Re: Amendment in Response to Orders for NOV 13148, Item 27 and 13150, Item 26, Sufco Mine, Canyon Fuel Company, LLC, Permit Number C/041/0002

Title: Amendment in Response to Orders for NOV 13148, Item 27 and 13150, Item 26

VOLUME 3
WASTE ROCK DISPOSAL SITE

SHEET NO.
APPENDIX V
FIGURE 1

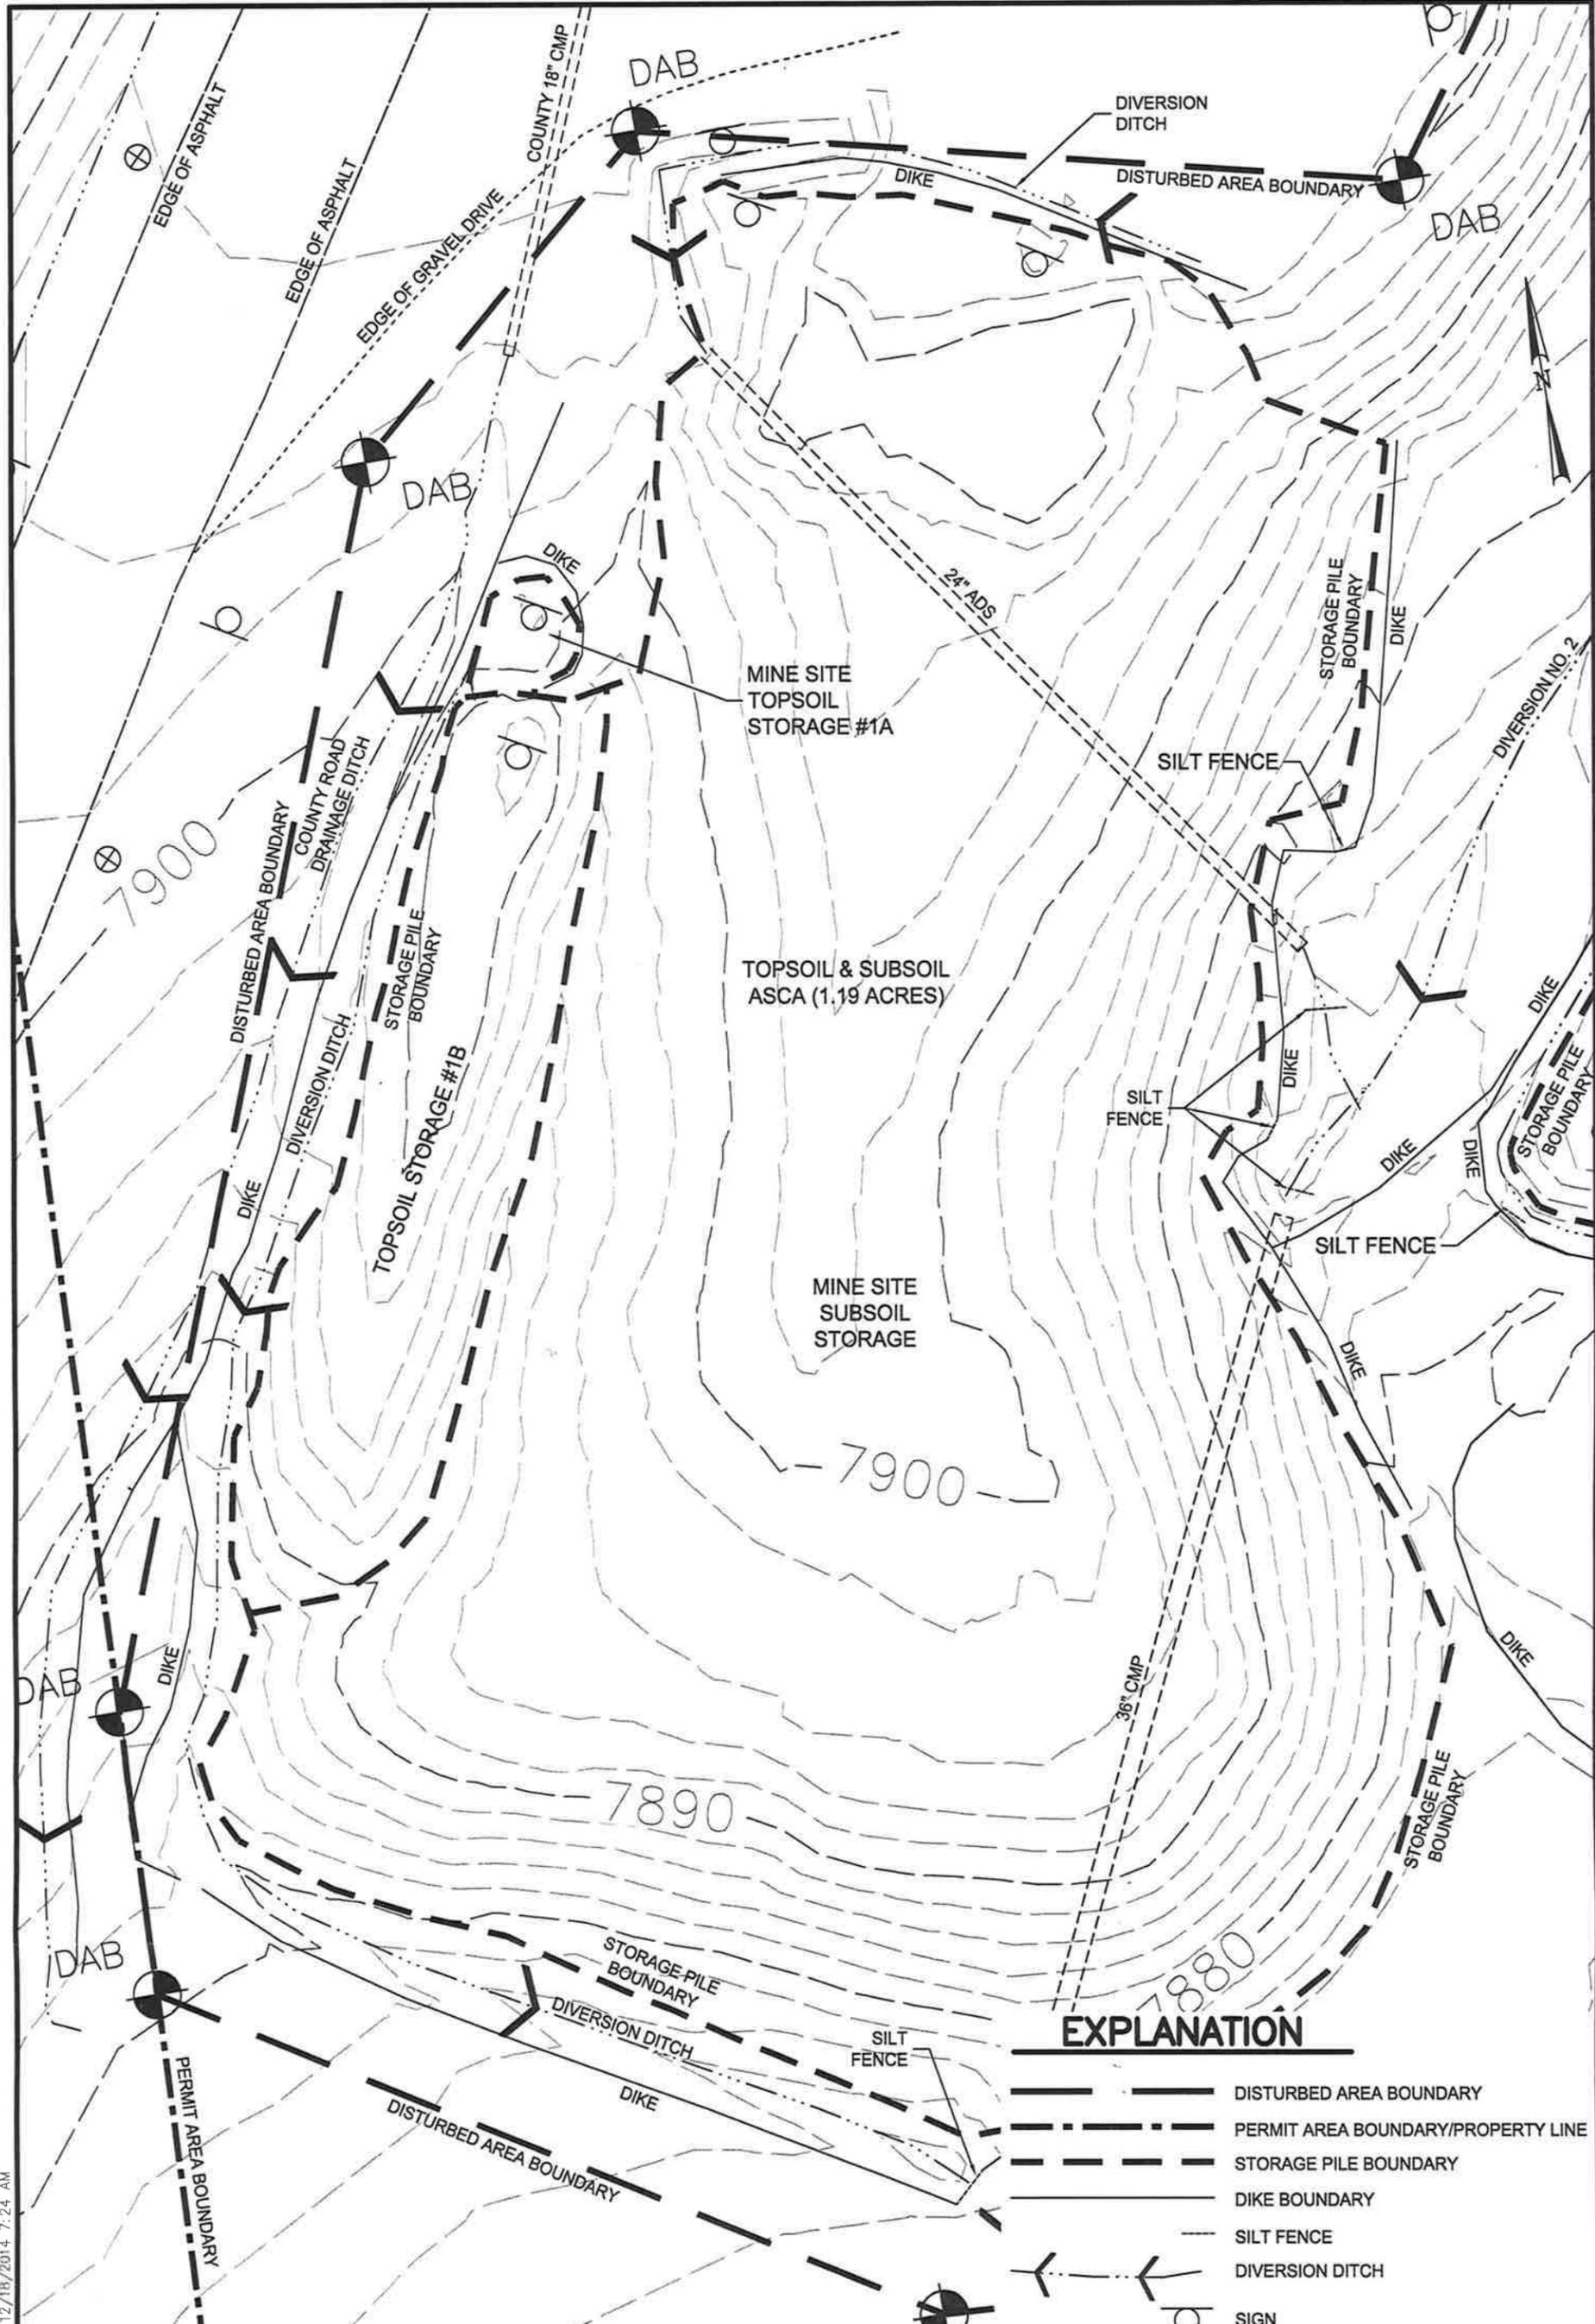
Please find enclosed with this letter an amendment to the Sufco Mine Permit to respond to the Letter dated November 20, 2014 – Findings of Fact, Conclusion of Law and Order for NOV 13148, 13149, 13150, 13151 and 13153. We have included two redline/strikeout copies of the text and of the figure associated with this amendment.
